## MERCEDES BENZ OF NOVI JSP17-78

Public hearing at the request of Mercedes Benz of Novi for Special Land Use, Preliminary Site Plan, and Storm Water Management plan approval. The subject property is 4.7 acres and is located in Section 24, on the west side of Haggerty Road and north of Grand River Avenue. The property is zoned B-3 General Business. The applicant is proposing to expand the parking lot to accommodate additional vehicle inventory parking for the existing vehicle dealership.

# PLAN REVIEW CENTER REPORT

**Review Date:** May 2, 2018  
**Review Type:** Revised Preliminary Site Plan – Final Site Plan  
**Project Name:** Mercedes Benz Parking Expansion  
**Location:** 39500 Grand River Ave; Parcel 22-24-426-010  
**Plan Date:** 4-11-2018  
**Prepared by:** Lindsay Bell, Planner  
**Contact:** E-mail: lbell@cityofnovi.org Phone: 248.347.0484

TITLE  
SITE PLAN  
MERCEDES BENZ OF NOVI  
CITY OF NOVI  
OAKLAND COUNTY, MICHIGAN  
SHEET  
CE2

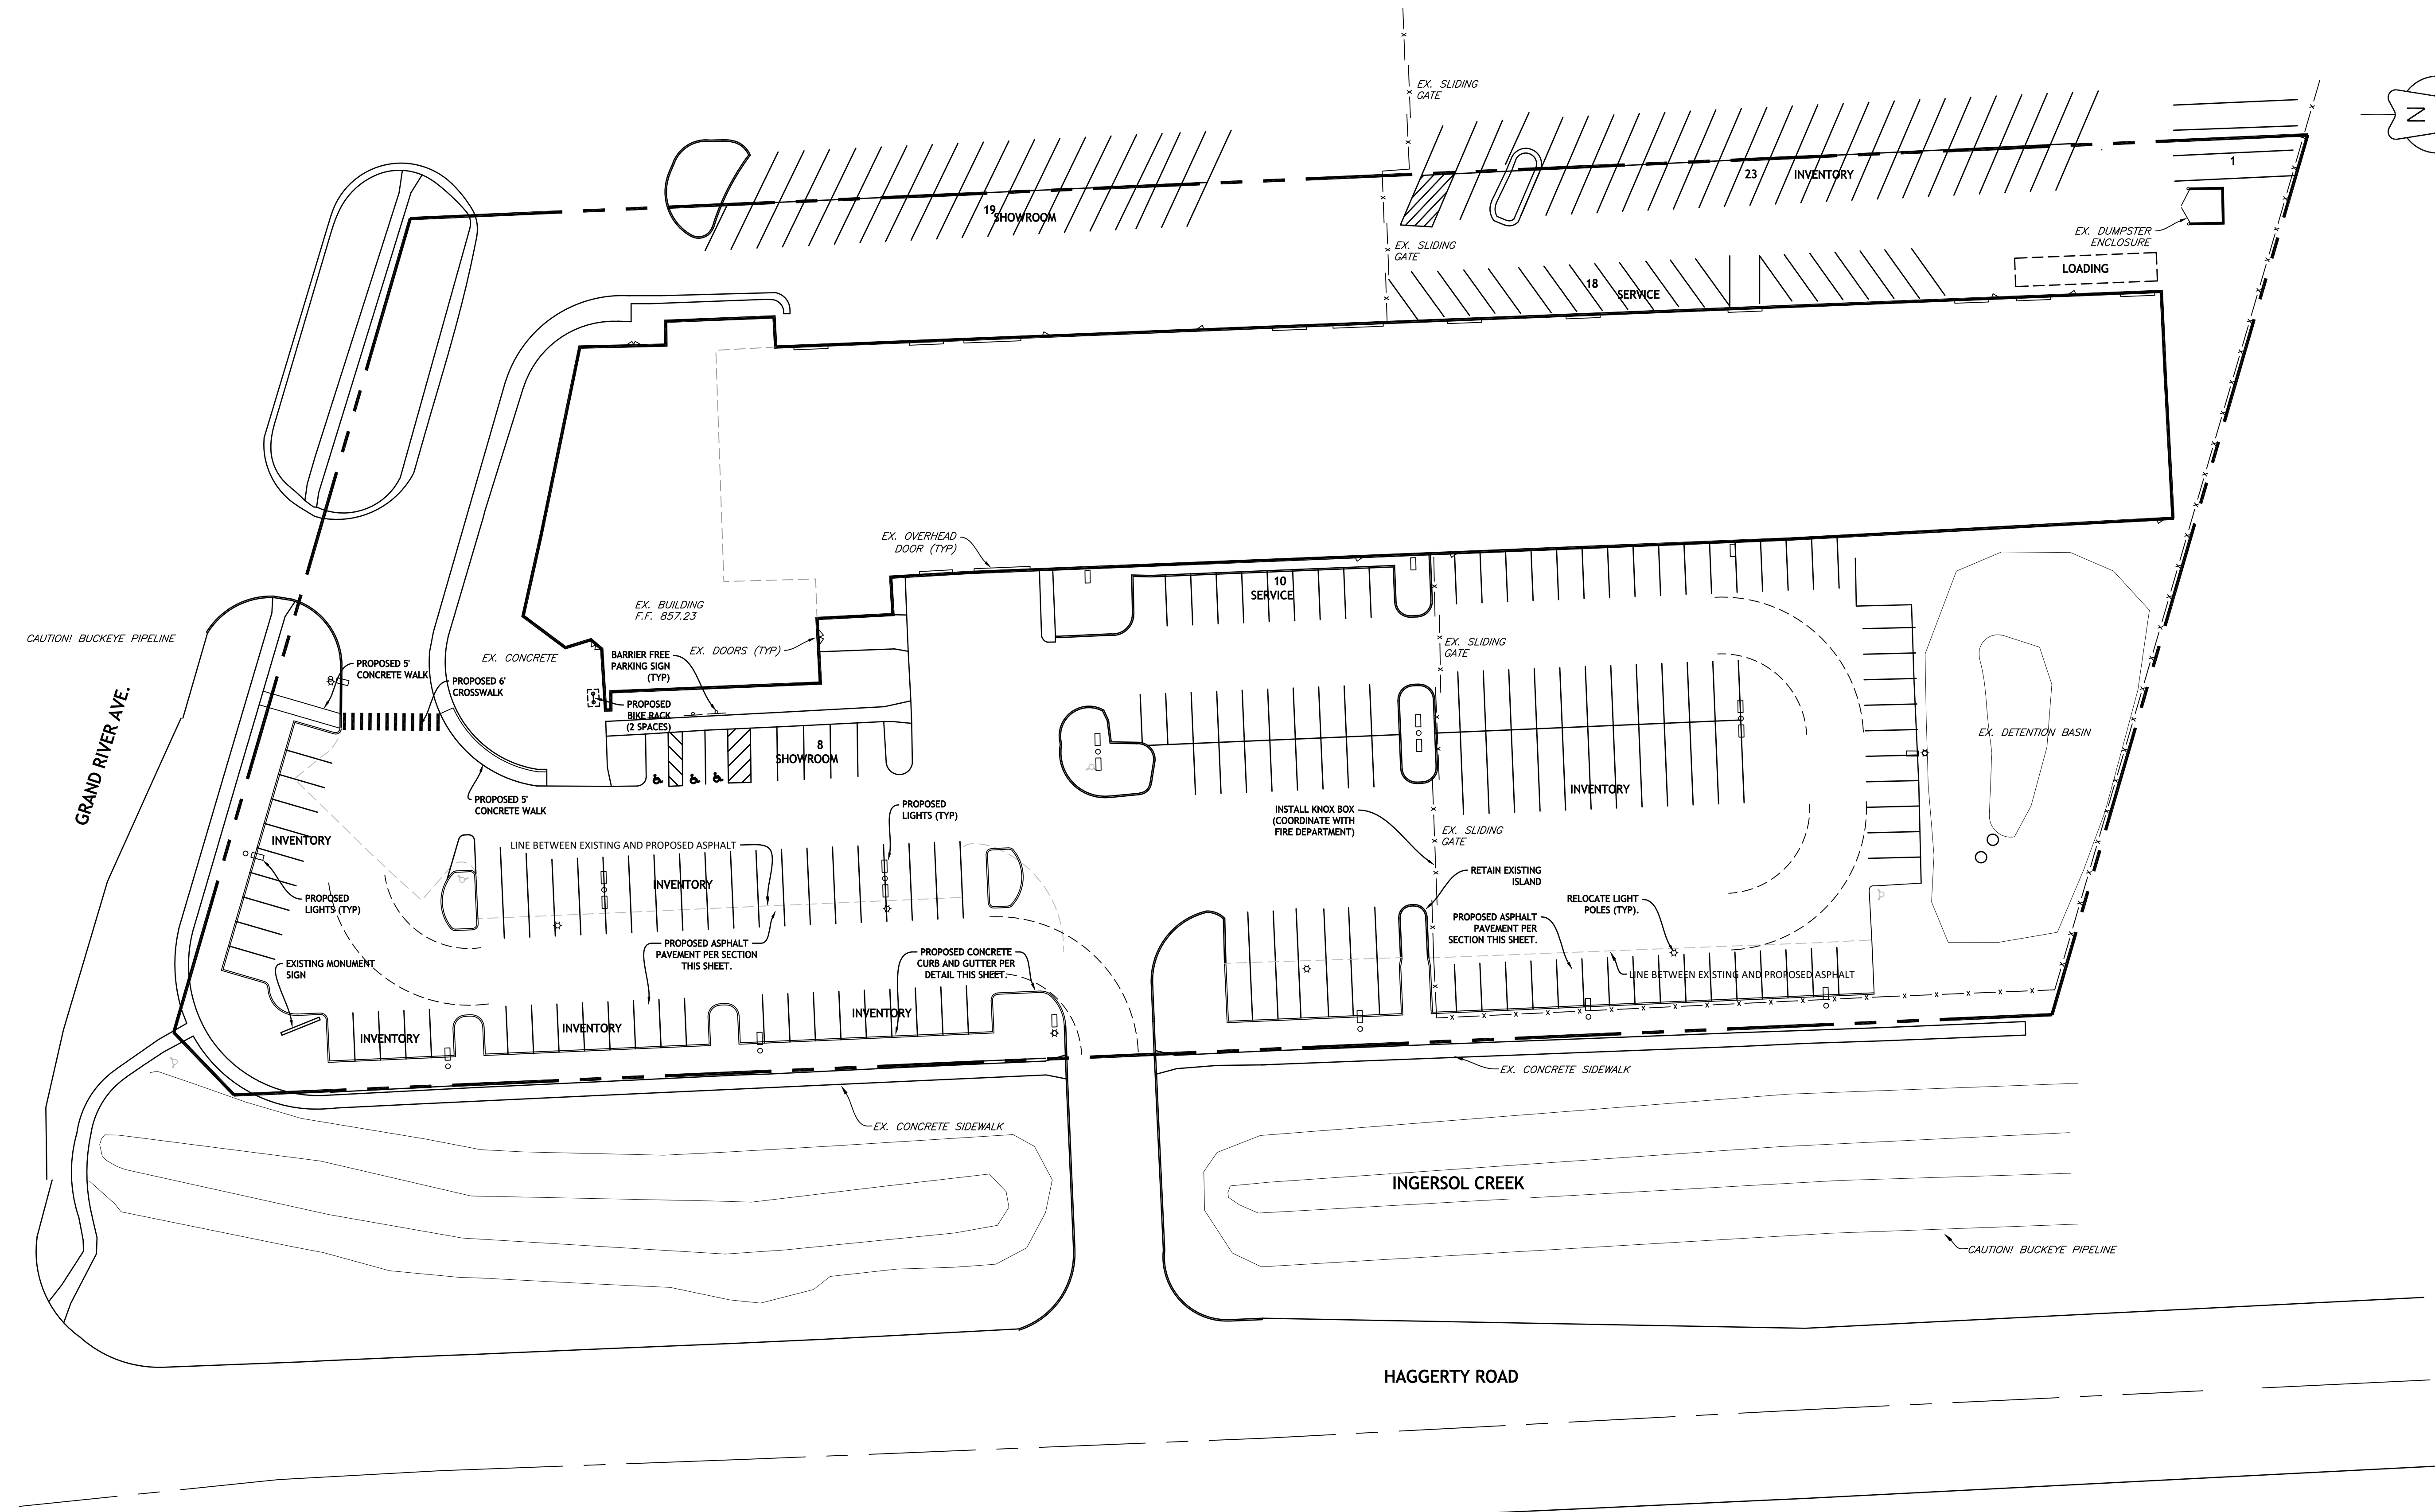
1. Existing trees and their diameters (dbh) are provided. None are in woodlands or are 36" dbh or larger.
2. **Please copy the tree fencing shown on the Landscape Plan to the site plan and grading plan.**

The tree protection fence and note are now included on sheet CE2 and CE4.

SHEET  
CE3

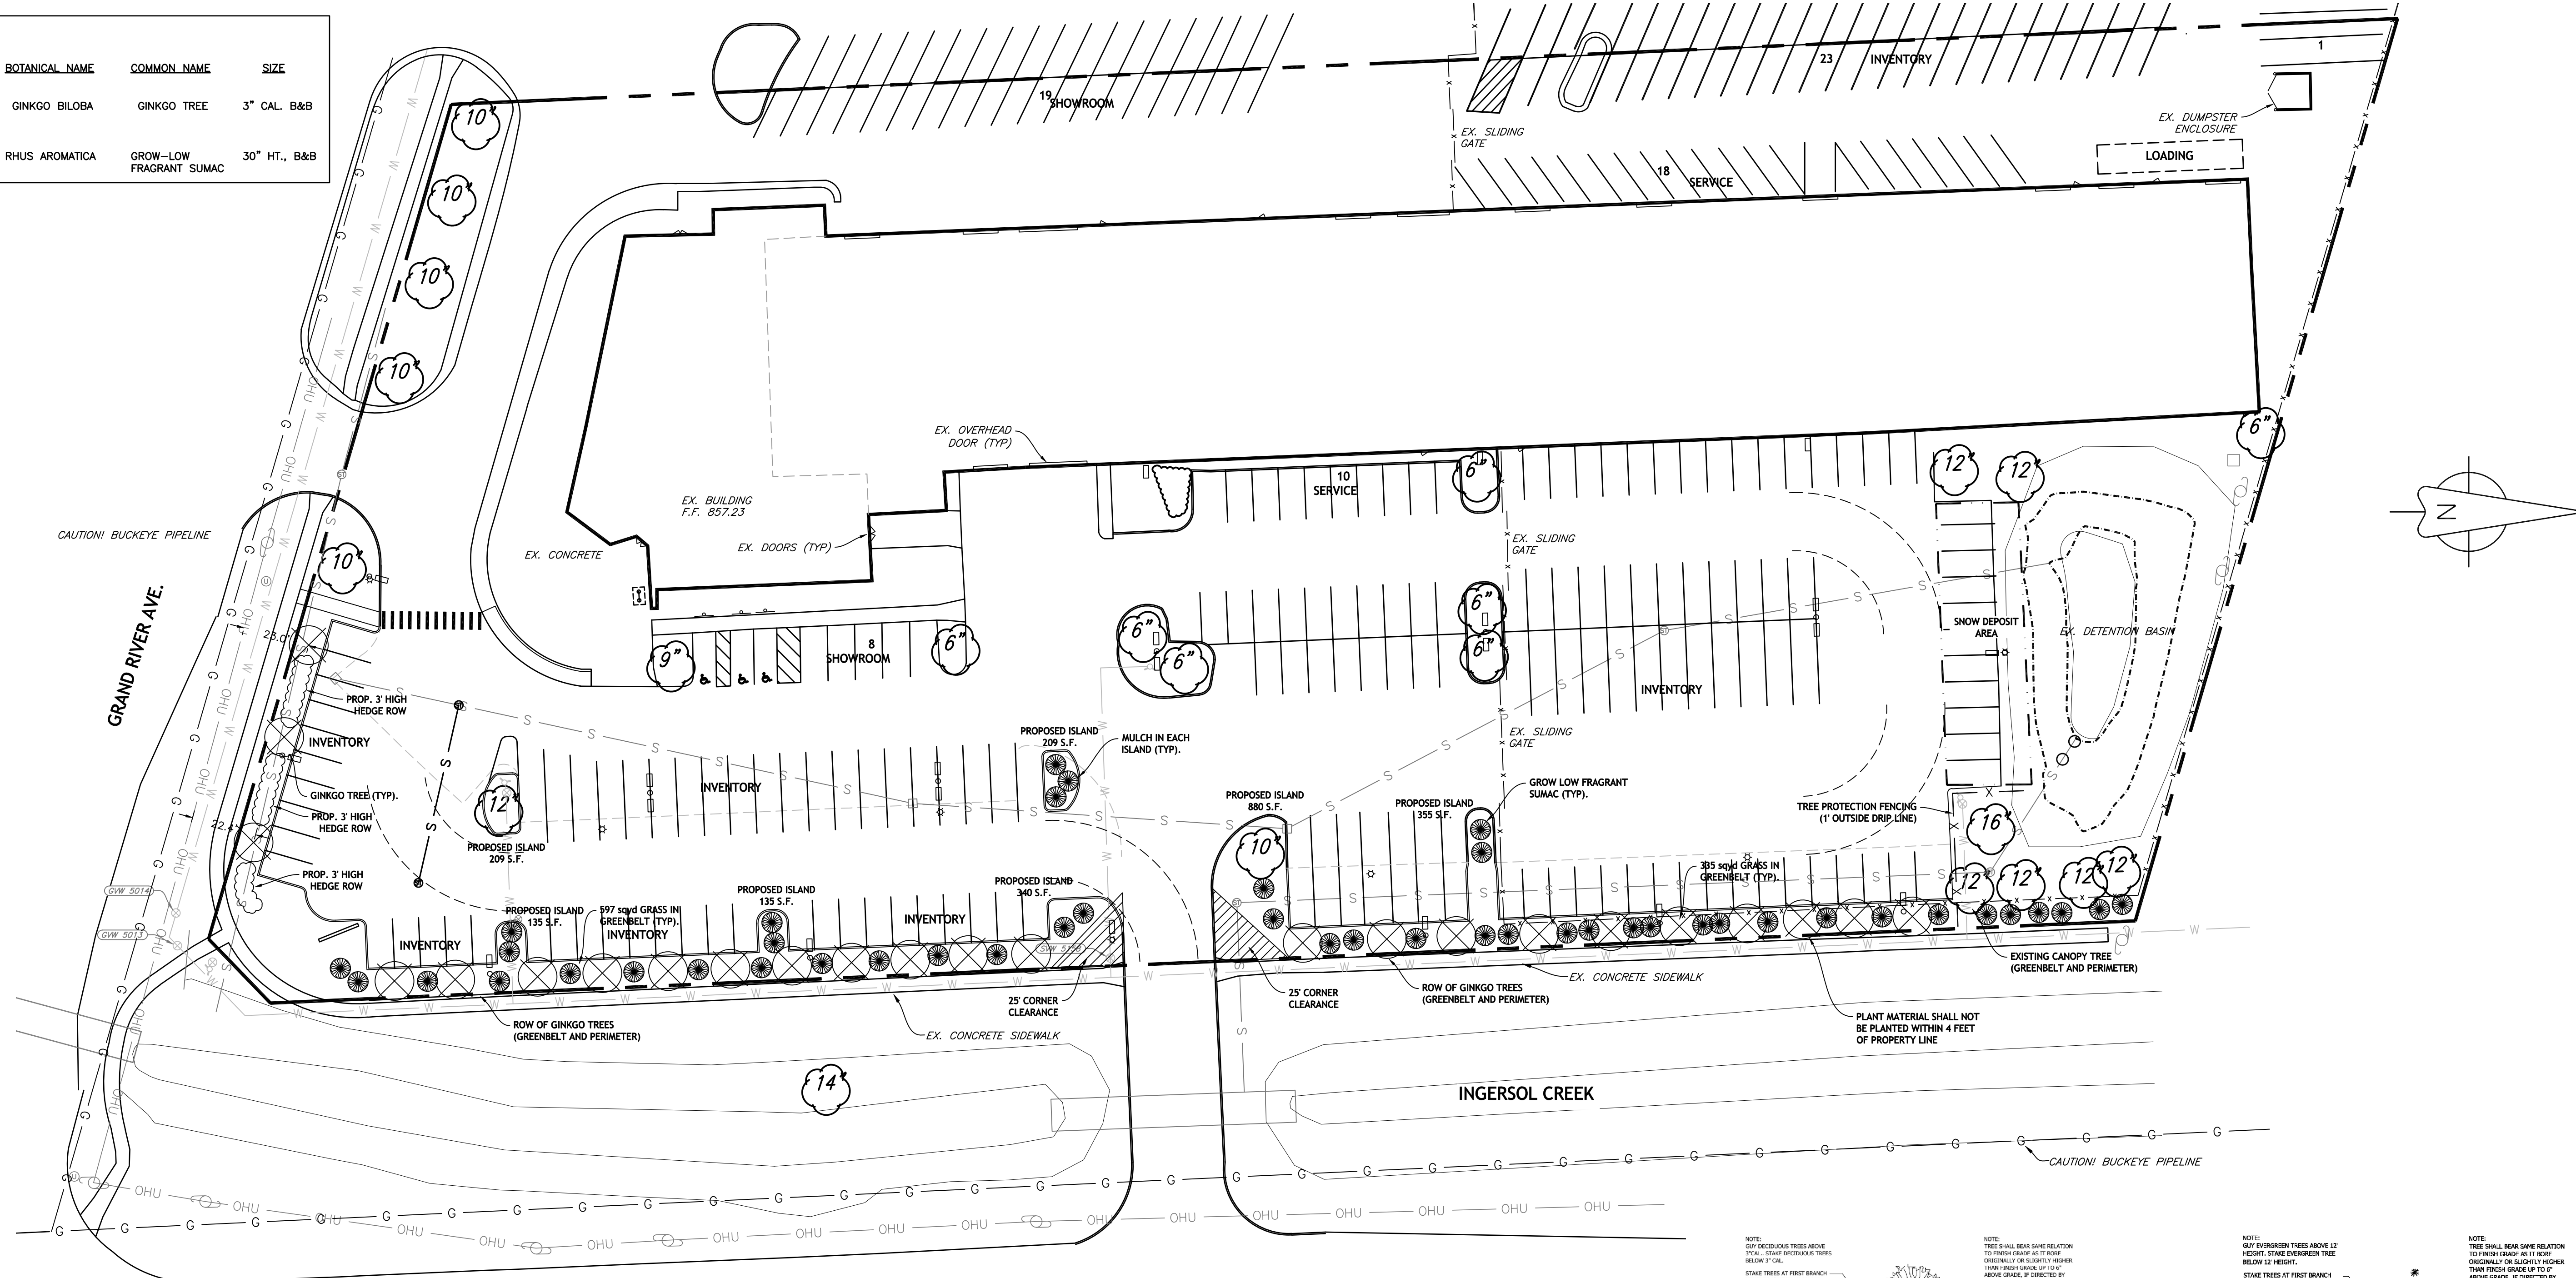
1. Clarify Parking Additions: Provide a total of current and proposed inventory parking spaces in the parking calculations so that the table accounts for all vehicles parked on-site.

The number of existing and proposed inventory spaces have been added to sheet CE3.

TITLE  
LANDSCAPE PLAN  
MERCEDES BENZ OF NOVI  
CITY OF NOVI  
OAKLAND COUNTY, MICHIGAN  
SHEET  
LS1

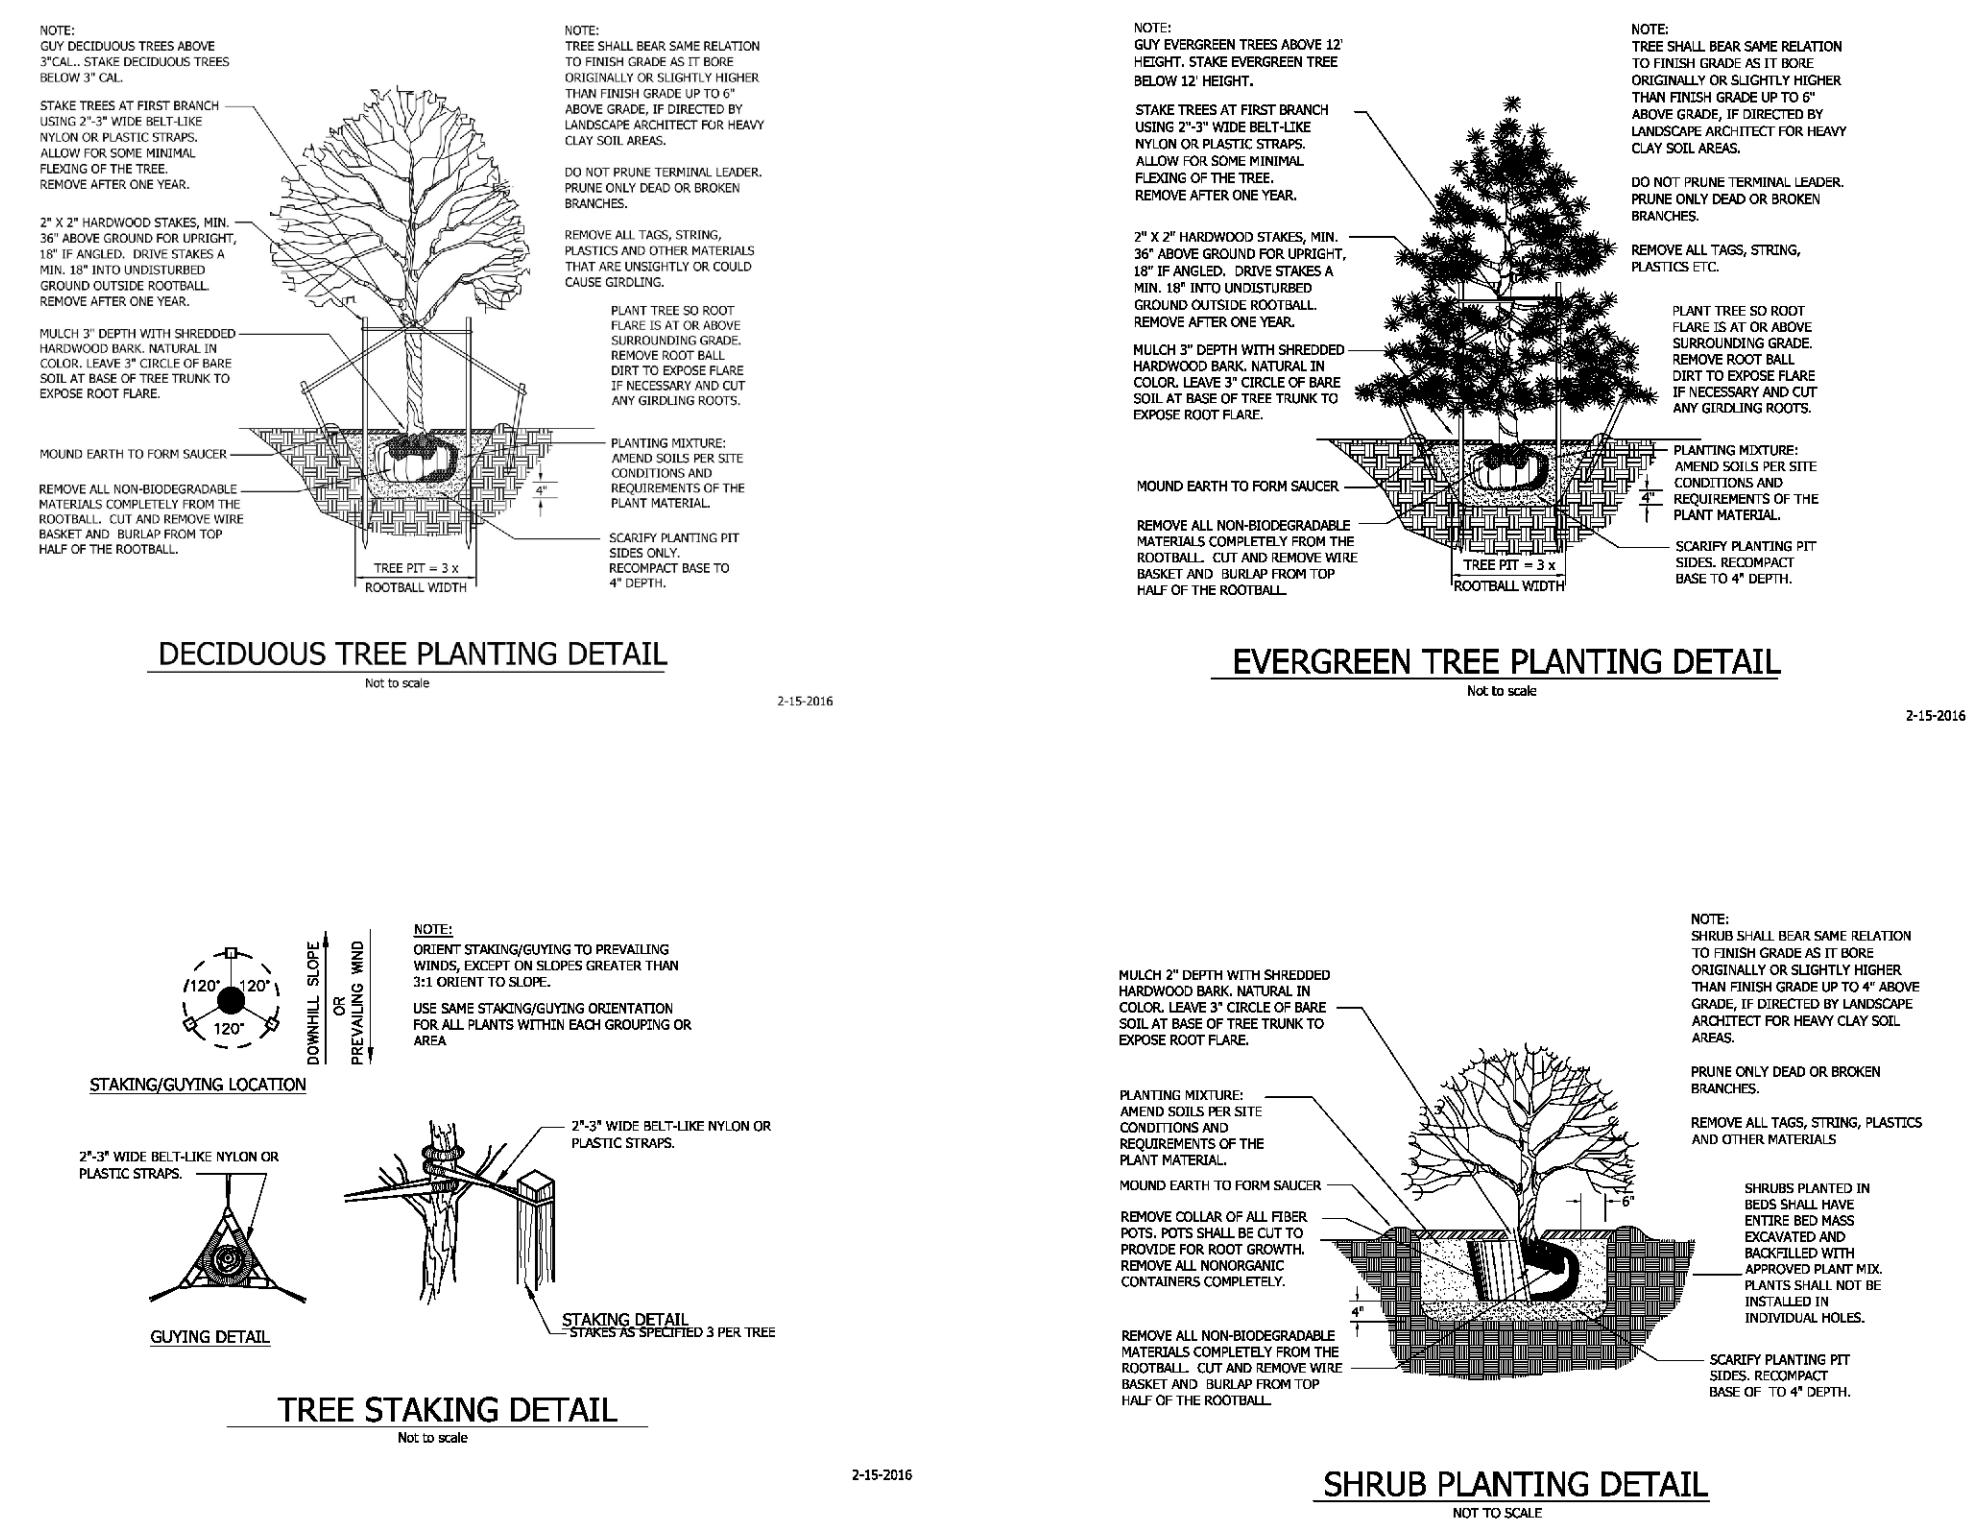
1. A 3 foot tall berm is required but is not provided. *A landscape waiver is requested to not provide this berm or a sufficient method of low level screening. This is not supported by staff as there is room to provide a sufficient, continuous shrub screen but the shrubs provided will not provide this screen.*

4. *There are several utility lines within the Grand River greenbelt. No trees (canopy or subcanopy) should be planted in this area. Based on the frontage and requirement, a landscape waiver for 1 canopy tree and 3 subcanopy trees for the trees that would be planted in this area would be supported by staff.*

5. **Please adjust the landscape plan to provide the correct number of trees based on the above points, and low-level screening.**

1. Provided.
2. **Please use at least 2 different species for the canopy trees to have some diversity in the plantings.**
